NON-INTENT INSTRUCTION TEMPORARY CHANGE

INSTRUCTION NO. PDB-P0001	REV. 1	INSTRUCTION TITLE CORE OPERATING LIMITS REPORT FOR THE PERRY NUCLEAR
CANCELS TCN(S): N/A	POWER PLANT, UNIT 2 CYCLE 4 (RELOAD 3)	
LIST EACH ATTACHED PAGE. 3		ADMIN. USE ONLY
PREPARER James M. Ruckel	DATE 3-4-93	INFORMATION ONLY
REASON CHANGES REFERENCE TO REVISION 2 FOR THE SUPPLEMENTAL RELOAD LICENSING REPORT. GENERAL ELECTRIC ISSUED A NEW REVISION TO DOCUMENT A CLARIFICATION PREVIOUSLY EXPLAINED PER TELECON.

INSTRUCTION NO PDB-F0001	REV 1	INSTRUCTION TITLE CORE OPERATING LIMITS REPORT	ADMIN. USE ONLY
FOR THE PERRY NUCLEAR POWER PLANT UNIT 1			
CANCELS TONIS: N/A			
LIST EACH ATTACHED PAGE 3, 30, 16, 17, 15

TITLE: CORE OPERATING LIMITS REPORT FOR THE PERRY NUCLEAR POWER PLANT,
UNIT 1 CYCLE 4 (RELOAD 3)

FIGURE 3.2.2-1

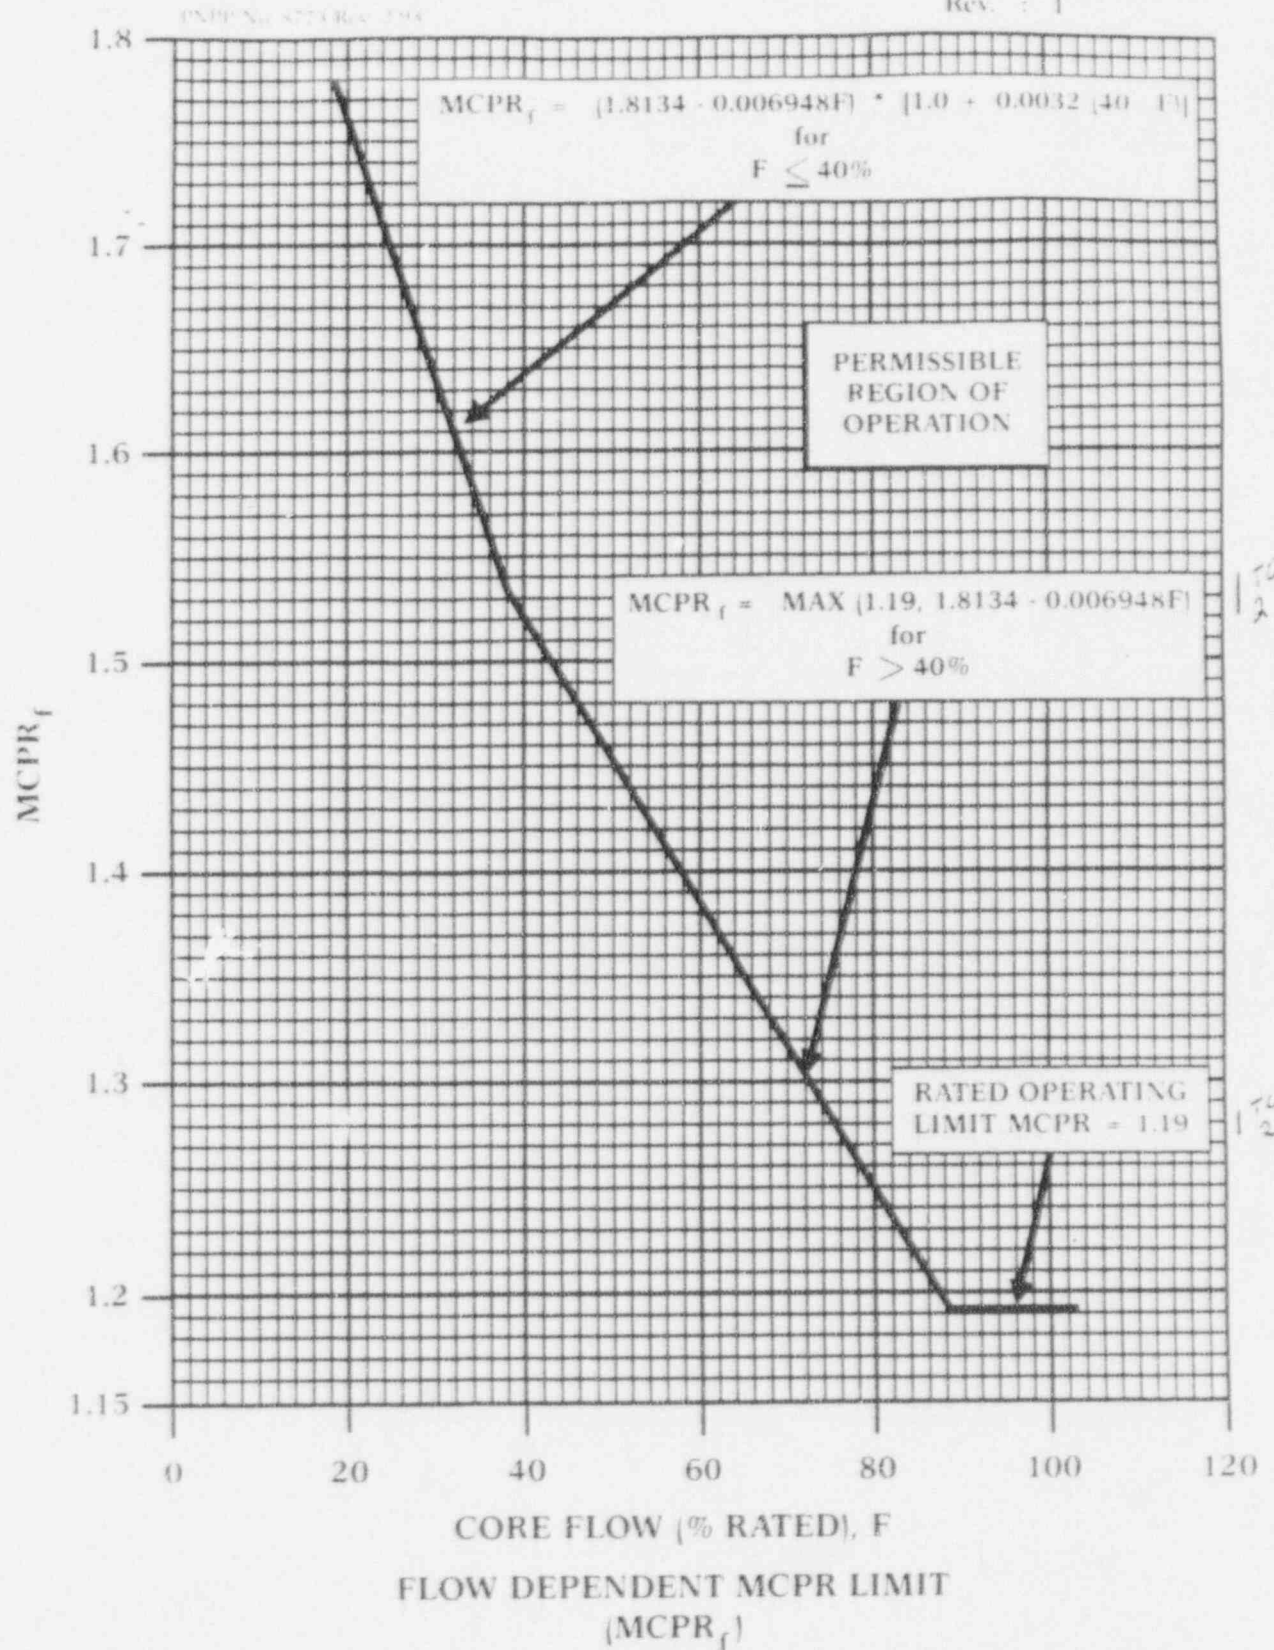
THE LOSS OF FEEDWATER HEATING TRANSIENT Δ CPR INCREASED FOR THE GE8X8EB/BP8X8R. FIGURES 3.2.2-1 AND 3.2.2-2 WERE REVISED AS APPROPRIATE. THE MCP_R AND MCP_P OFFSETS WERE REVISED FOR PLANNED FEEDWATER REDUCTION.

NOTE: MCPR limits are fuel type dependent and ΔT dependent. The $MCPR_f$ and $MCPR_p$ limits are applicable for all core average exposures, nominal rated feedwater temperature (420°F), and all core flows less than or equal to 105% core flow. For planned reduction of rated feedwater temperature from rated feedwater temperature (420°F), increase the appropriate $MCPR_f$ and $MCPR_p$ limits by the following offset:

FW Temperature ***	GE8X8EB, BP8X8R (Fig. 3.2.2-1, 3.2.2-2)	GE8X8NB-3 (Fig. 3.2.2-3, 3.2.2-4)
420 to 370°F	0.0	0.0
420 to 320°F	0.0	0.0
420 to 250°F	0.01	0.0
